**Subject: Onejoy Place  
Response to Peer Review Comments**

Our office received peer review comments for the above referenced project from Thomas Errico, P.E. at T.Y. Lin International, dated July 7, 2017 and Lauren Swett, P.E. and Craig Sweet, EIT at Woodward & Curran, dated July 6, 2017. We have reviewed the comments and have prepared the responses presented below. For clarity, each comment is repeated in italics, followed by our response.

SHEET DESCRIPTION  
VEHICLE MANEUVER #1  
ONEJOY PLACE  
1 JOY PLACE, PORTLAND, MAINE

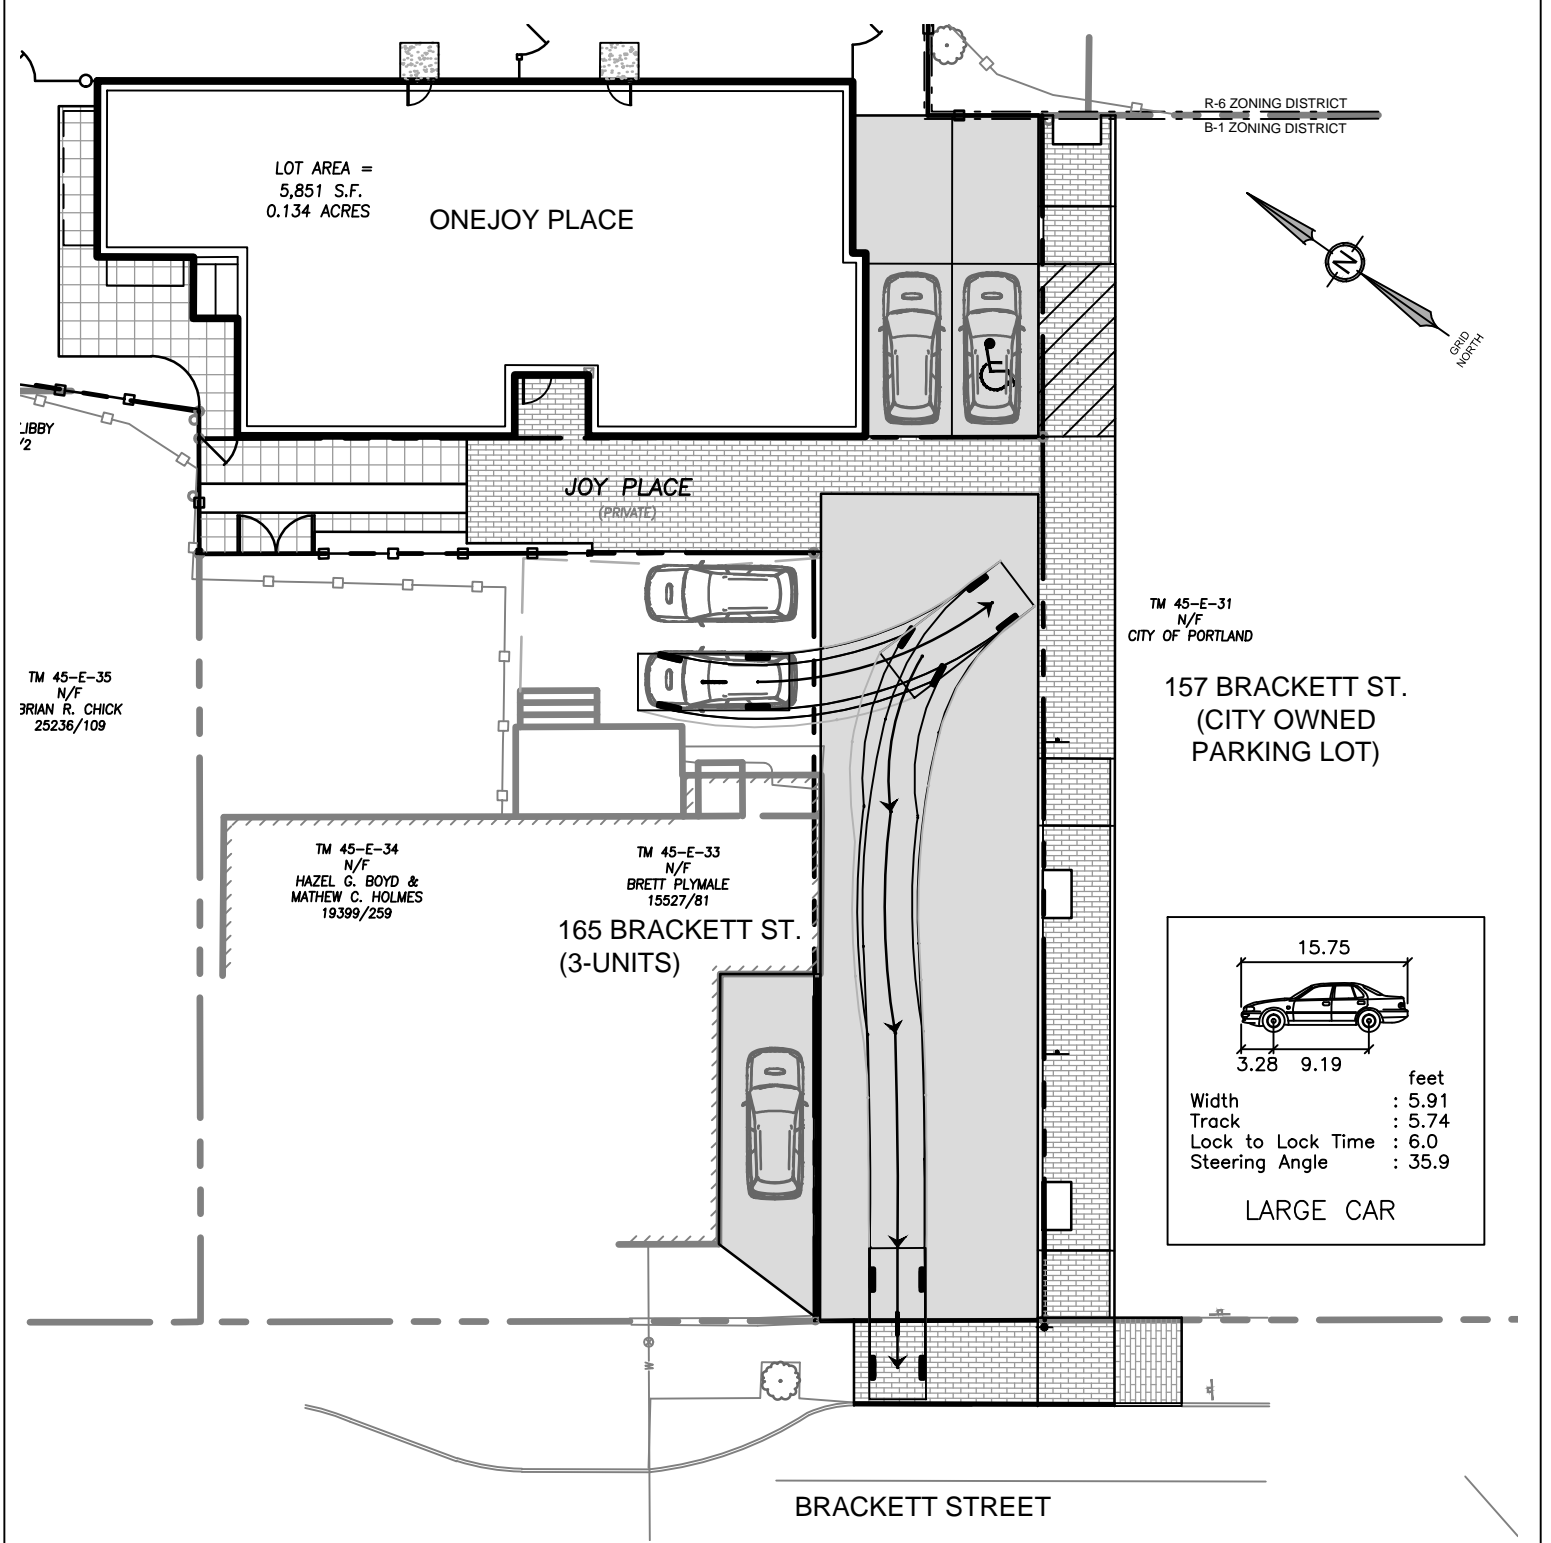
*Comment 3: It is my understanding that parking for the abutting property will be provided in the rear of the building and along Joy Place. A parking layout plan shall be provided that illustrates how the three vehicles will park and circulate into and out of the spaces. I'm concerned about the parking area along Joy Place and encroachment into the driveway access/egress area (and ensuring only one parallel vehicle parks).*

*Comment 4: I do not recommend backing maneuvers from Joy Place onto Brackett Street and thus the applicant should demonstrate that vehicles can turn around on site.*

Response: The abutting 3-unit building at 165 Brackett Street has on-site parking accessed from Joy Place. Two parking spaces are located in a gravel area behind the building, and one spaces is located parallel to Joy Place, on the south side of the building. Access to these spaces will be maintained throughout and after construction. The parallel space will be paved and delineated with flush granite as part of the proposed project, and signs will be installed along Joy Place to prohibit parking within the right of way.

Our office prepared a series of Vehicle Maneuver Figures to demonstrate that vehicles can turn around on site. The figures are attached.

Response: Our office prepared a series of Vehicle Maneuver Figures to demonstrate that vehicles can turn around on site. The figures are attached.
